GUARDRAIL APPROACH TRANSITIONS AND CONNECTIONS FOR EXISTING FLAT SLAB, PRESTRESSED BEAM AND GIRDER BRIDGES WITH SAFETY SHAPE TRAFFIC RAILING BARRIER EXTENDING LESS THAN FULL APPROACH SLAB LENGTH

STATE OF FLORIDA DEPARTMENT OF TRANSPORTATION ROAD DESIGN			
GUARDRAIL			
INTERIM STANDARD	APPROVED BY	<i>[Signature]</i> STATE ROADWAY DESIGN ENGINEER	
THIS SHEET REPLACES INDEX NO. 400 (SHEET 13 OF 31) OF THE METRIC ROADWAY AND TRAFFIC DESIGN STANDARDS, BOOKLET DATED JANUARY 2000.			
REVISION NO.	SHEET NO.	INDEX NO.	
00	13 of 31	0400

DETAIL N

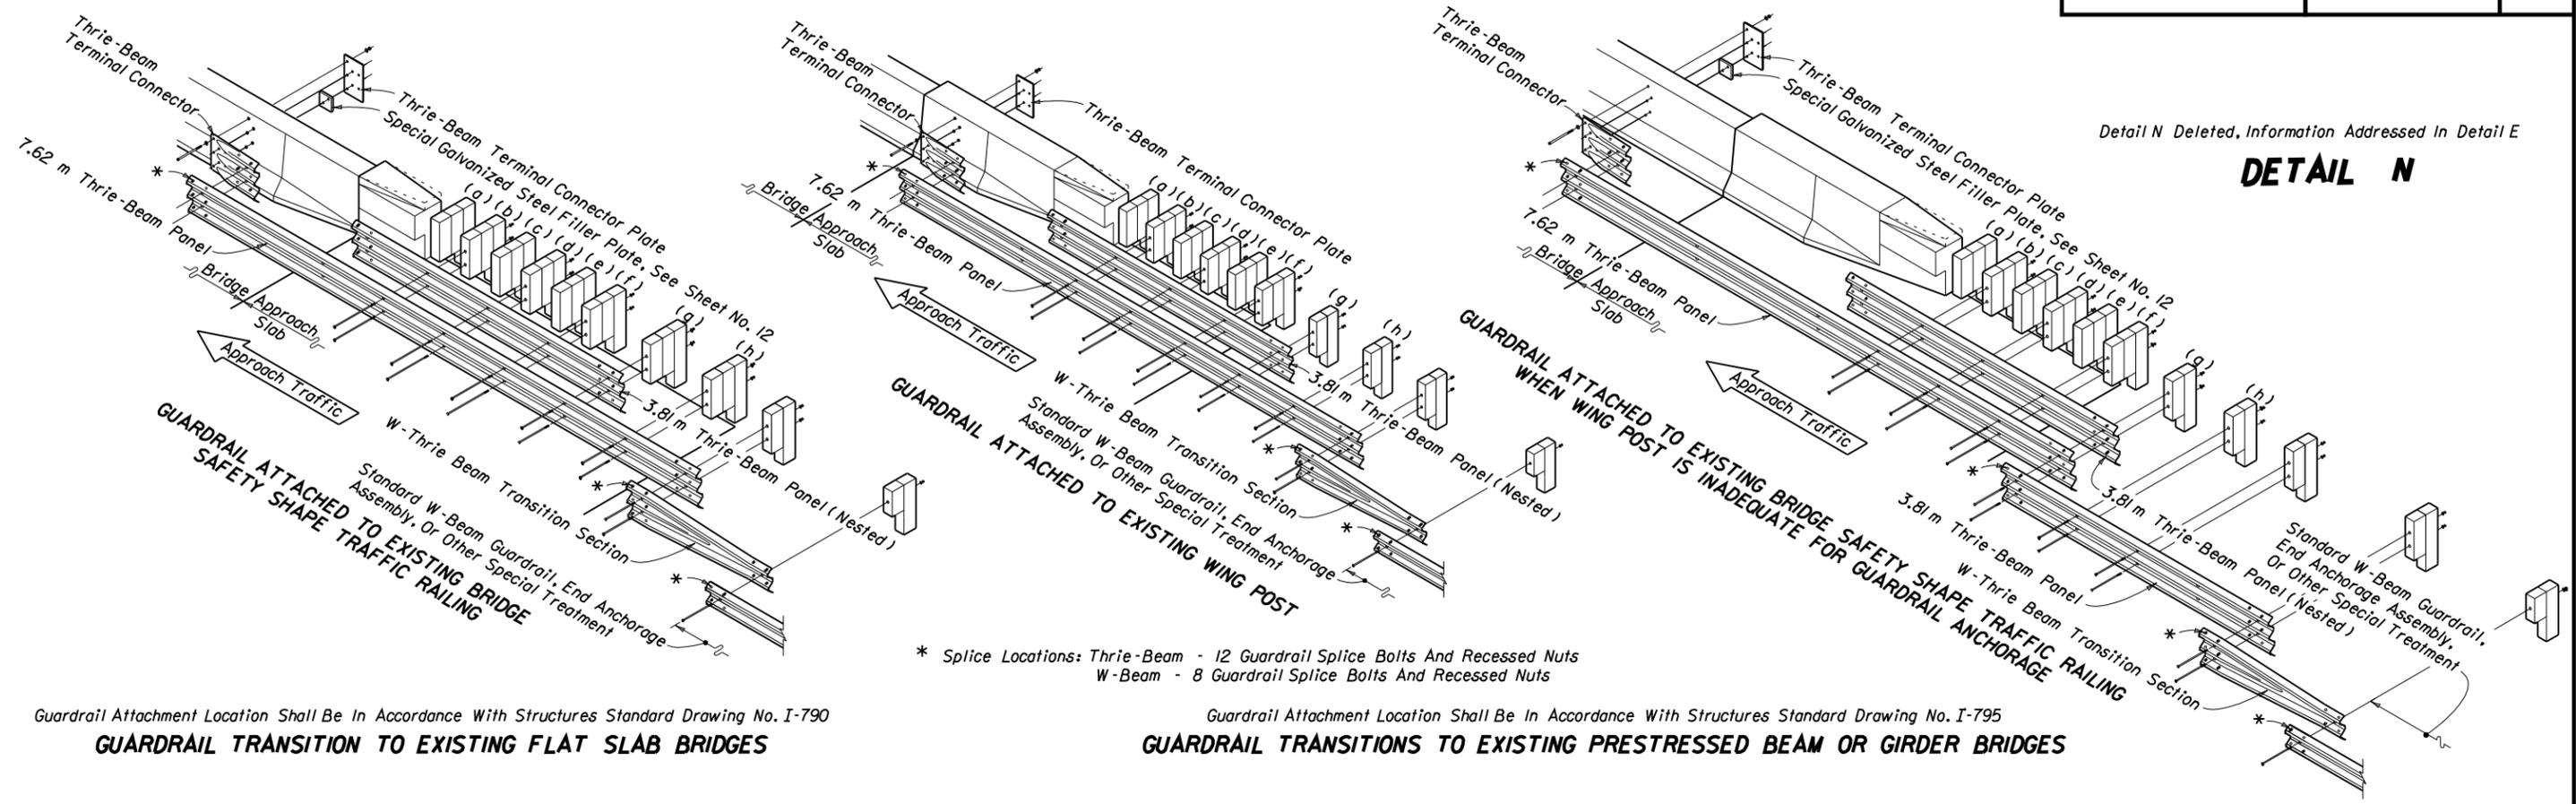
Detail N Deleted, Information Addressed In Detail E
